METROPOLITAN GOVERNMENT OF NASHVILLE AND DAVIDSON COUNTY

STAFF RECOMMENDATION
731 McFerrin Avenue
July 17, 2013

Application: New construction – outbuilding, Violation
District: Greenwood Neighborhood Conservation Zoning Overlay
Council District: 06
Map and Parcel Number: 08208030700
Applicant: Cees Brinkman
Project Lead: Robin Zeigler, robin.zeigler@nashville.gov

This image shows the similarity in height between the primary building, which is estimated at about 18' and the outbuilding, which is estimated at 16' from grade at its tallest point.

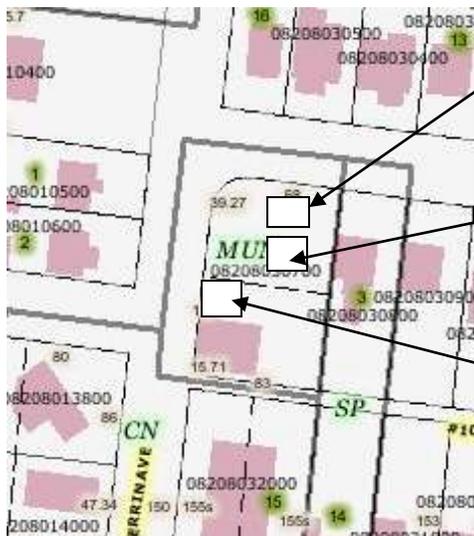
Height & Scale: The exact height of the structure is unknown as the drawings are not to-scale. Based on a rough measurement and comparison to the house next door which is approximately eighteen feet (18’) tall from grade, the outbuilding is approximately sixteen feet (16’) from grade at its highest point. The footprint is three hundred and eighty four square feet (384 sq. ft.). The height is inappropriate since the outbuilding is close to the same height as the primary building next door, which is within the height range of historic buildings in the immediate vicinity, and is highly visible from two public right-of-ways. Typically, outbuildings are subordinate to historic primary buildings. The project does not meet II.B.a and b.

This is the general current location of the structure.

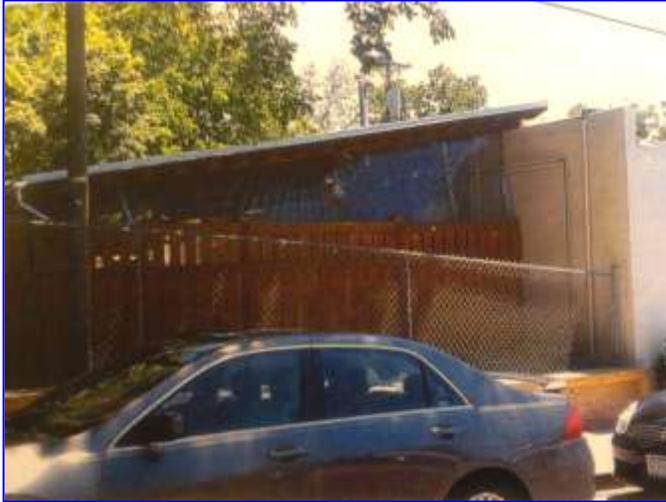
Setback, Orientation & Location: Because this is an outbuilding on a corner lot, it should be located towards the center of the lot and the interior lot line, where historic outbuildings were located. (See Sanborn Map on page three.) In this case, the structure sits forward of the historic homes to the left with a ten foot (10') setback. The setbacks of homes on this block of Chicamauga are between thirty-two and thirty-four feet (32'-34') from the front property line. The location is inappropriate.

The orientation of a primary building on this lot should be towards Chicamauga, as the corresponding lot across the street has a house facing Chicamauga and historic maps show this type of development. The structure is an outbuilding and so should be oriented towards the rear of the lot even though a primary building does not exist or is planned. Currently, the outbuilding is oriented more like a primary building than an outbuilding. The project does not meet section II.B.c and f and II.B.i.2.

This is the appropriate location for the structure, based on historic precedent and context and the requirements of the design guidelines.

This image shows the plastic material added to the pre-approved side addition, facing McFerrin Avenue.

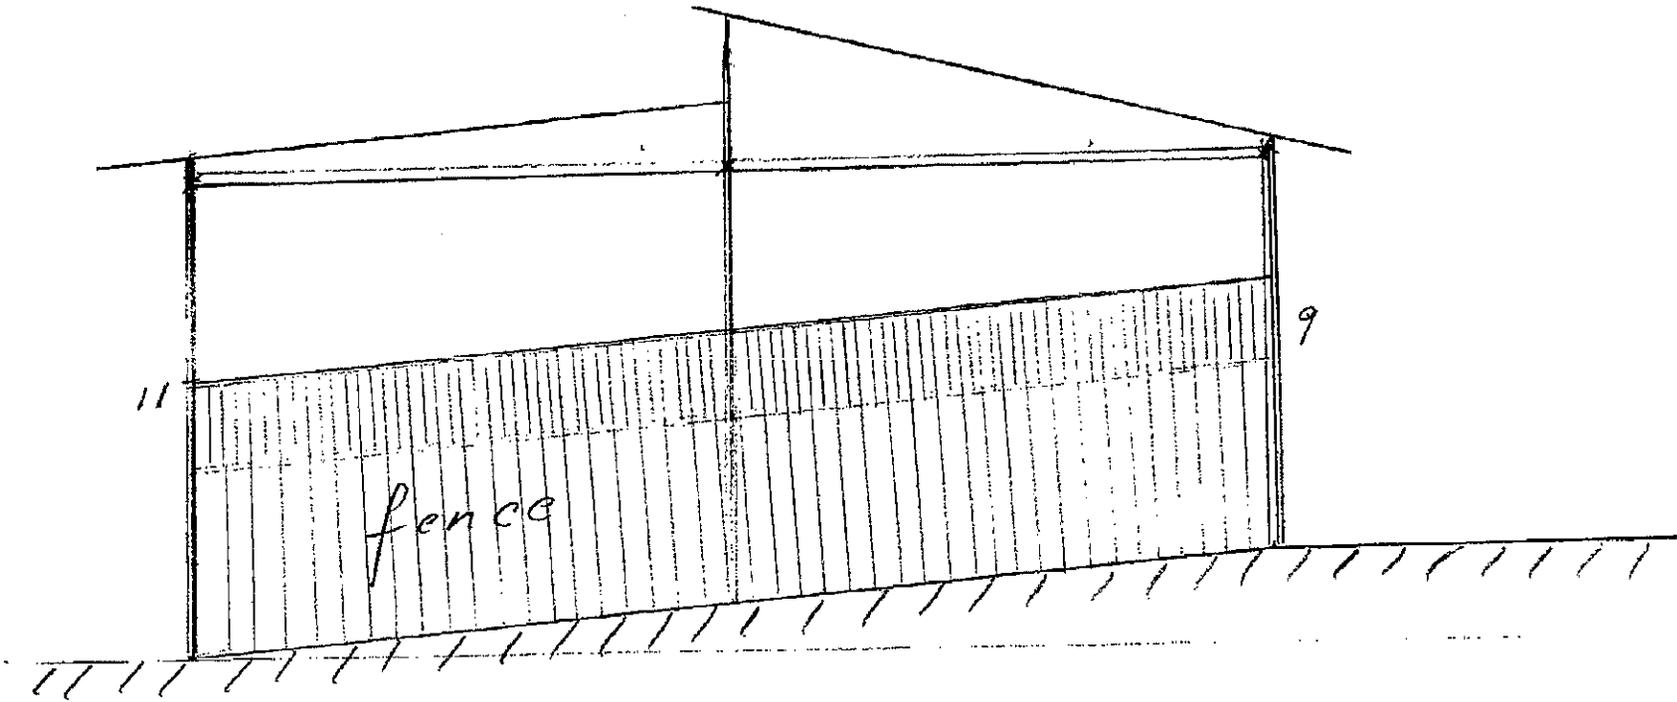
The plastic siding that is installed from the top of the fence to the top of the previously approved side addition is not an appropriate material for cladding and has been disapproved by the Commission in the past. The addition was approved as an open-air structure, without sides. Staff recommends removal of the siding.

Recommendation: Staff recommends disapproval of the current outbuilding and of the plastic sides added to the pre-approved side addition. Staff recommends that the structure and the plastic siding be removed within 30 days of the hearing. Staff finds that the projects do not meet the guidelines in terms of location and materials (II.B.a., b, c, d, f, and i) for the Greenwood Neighborhood Conservation Zoning District.
